March 1, 2017

Subject: Response to Comments in SCDHEC Letter titled "Corrective Action Plan Review," dated January 27, 2017 (with errata dated January 31, 2017)
Plantation Pipe Line Company
Lewis Drive Remediation Site
Belton, South Carolina
Site ID #18693, "Kinder Morgan Belton Pipeline Release"

Attachment 1
Figure 9a, Proposed Sparging Layout
(Large Format)

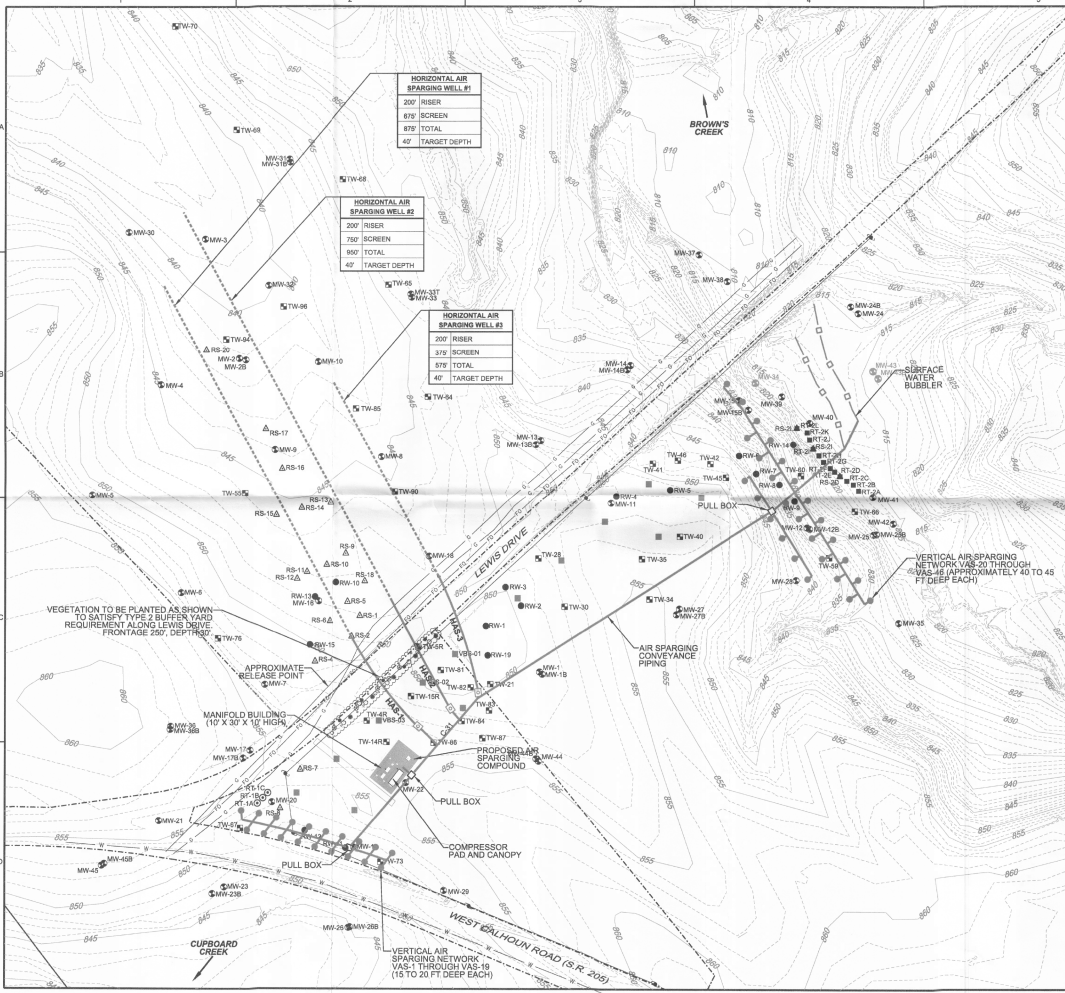
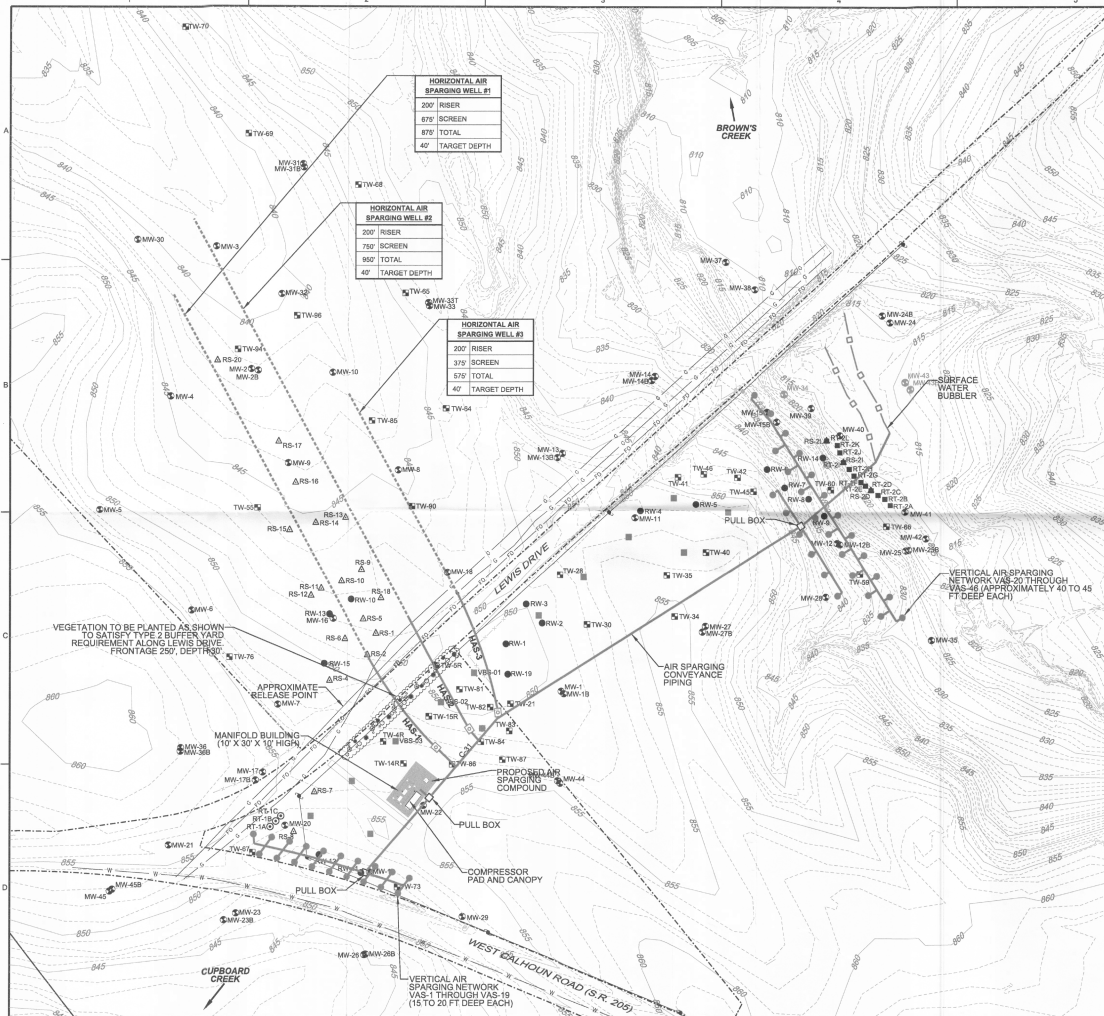
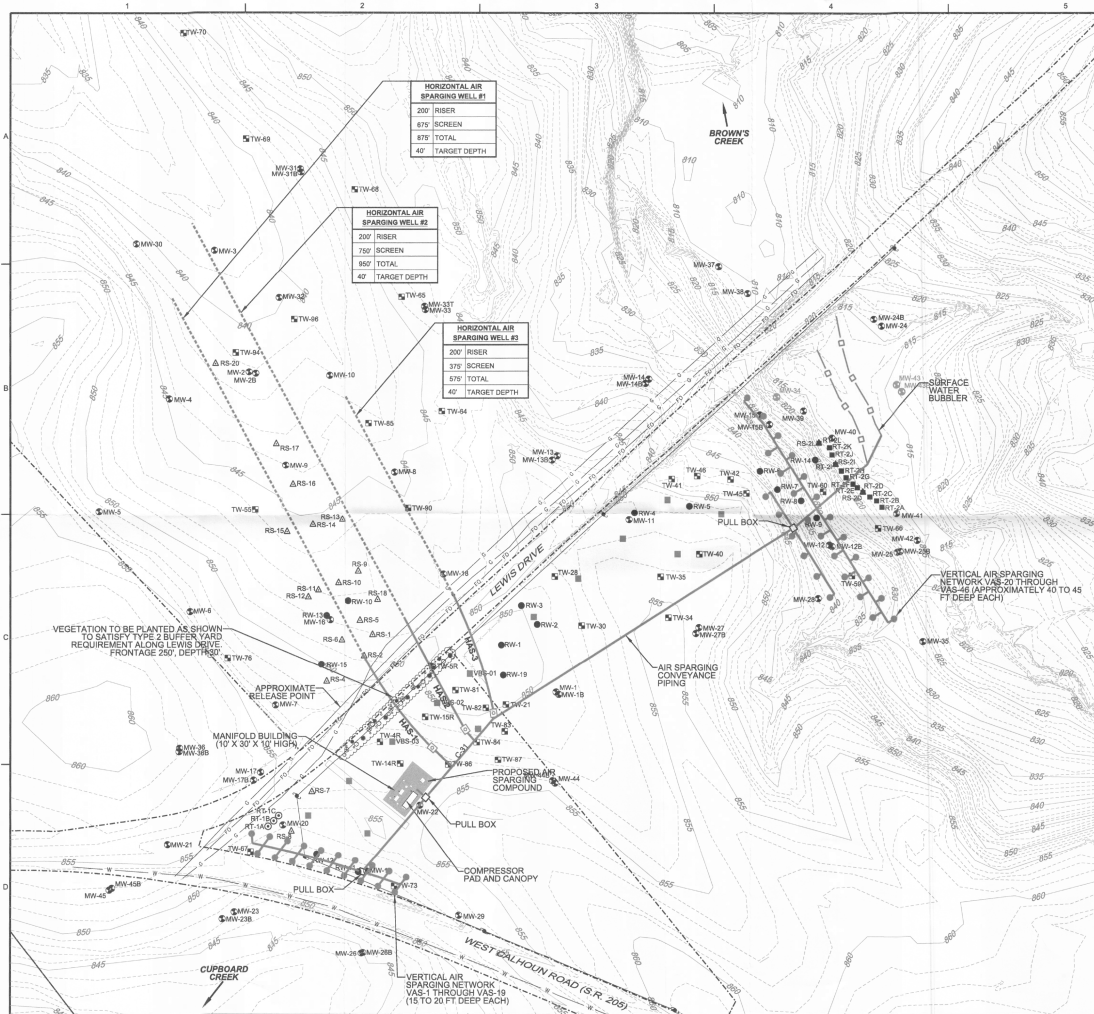
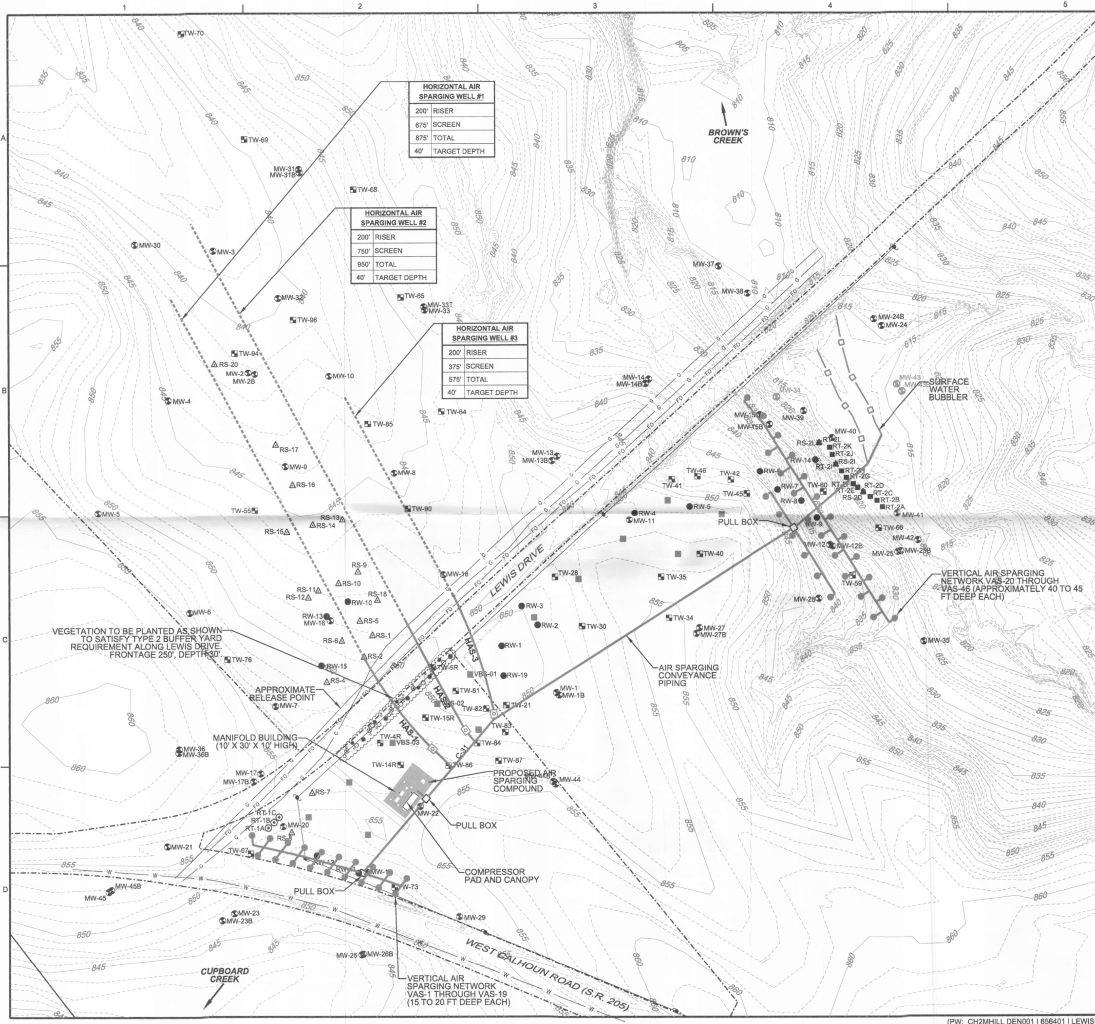
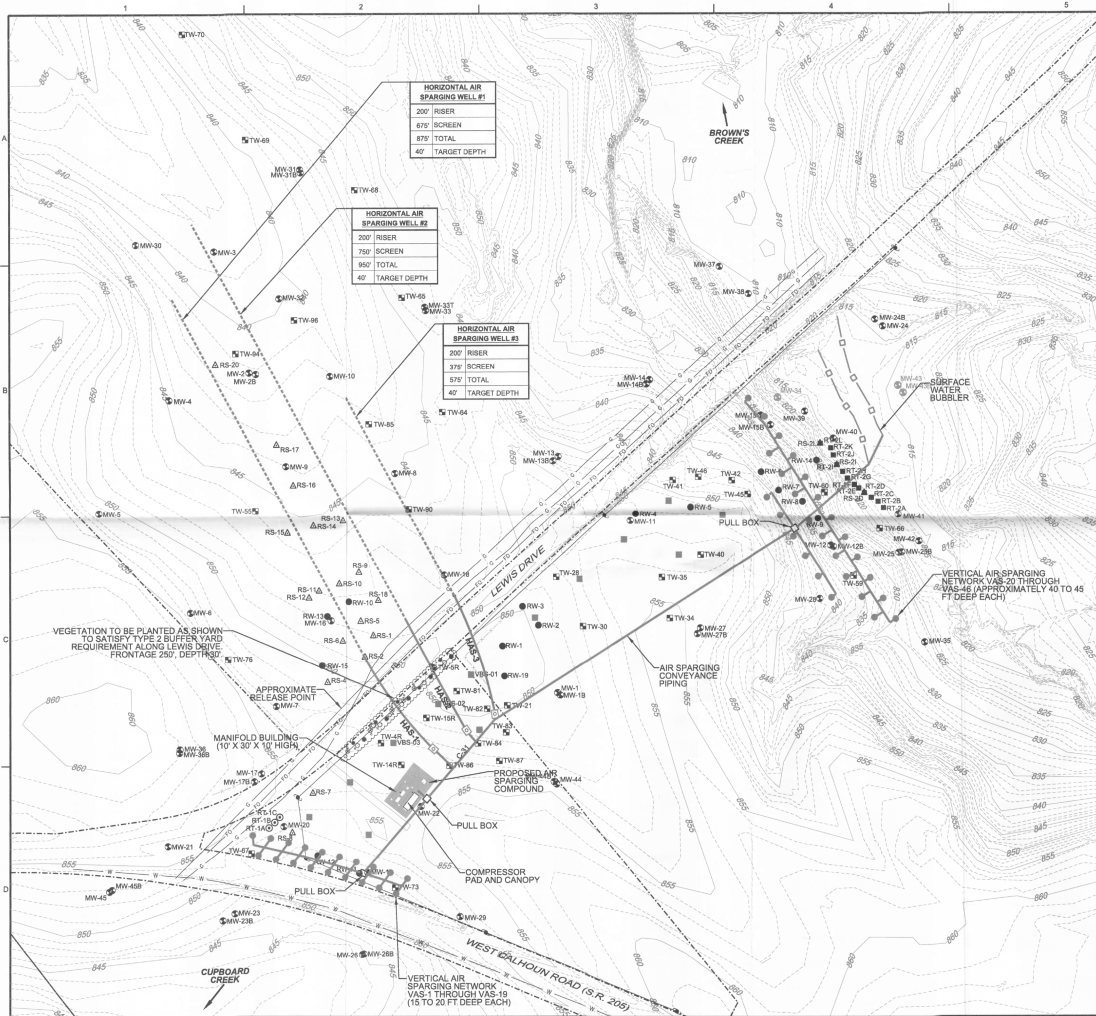
Comment 2: *A larger map of the proposed biosparging layout than was provided (Figure 9). The revised map will need to clearly illustrate the layout, all wells, trenches, sumps, and the creeks.*

Response: Figure 9 has been reprinted on 22- by 34-inch paper. See Figure 9a included in Attachment 1. Five copies have been provided.

Attachment 2
Well Construction Diagrams for
MW-44, MW-44B, MW-45, and
MW-45B

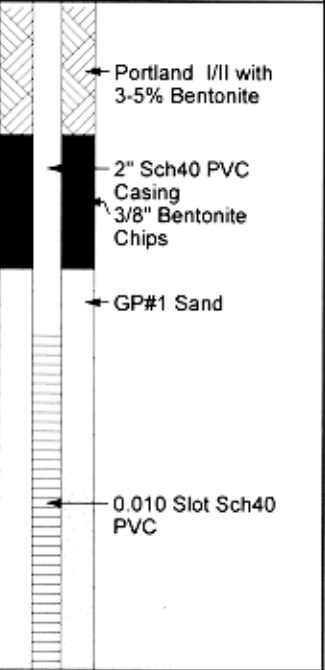
Comment 11: *Installation of an additional permanent bedrock well down-gradient of MW-17B, located between the area of MW-17B and MW-21 along the pipeline. This well should be as close in proximity to the pipeline as is MW-17B.*

Comment 12: *Installation of permanent wells (shallow & bedrock) in the area between MW-1 and MW-22.*

Response: Installation of permanent shallow and bedrock well pair MW-45/45B was completed on January 27, 2017, in close proximity to the pipeline and downgradient of MW-17B. Combination boring logs/well construction diagrams for MW-45 and MW-45B are included in Attachment 2.

Response: Installation of permanent shallow and bedrock well pair MW-44/44B was completed on January 25, 2017, in the area between MW-01 and MW-22. Combination boring logs/well construction diagrams for MW-44 and MW-44B are included in Attachment 2.
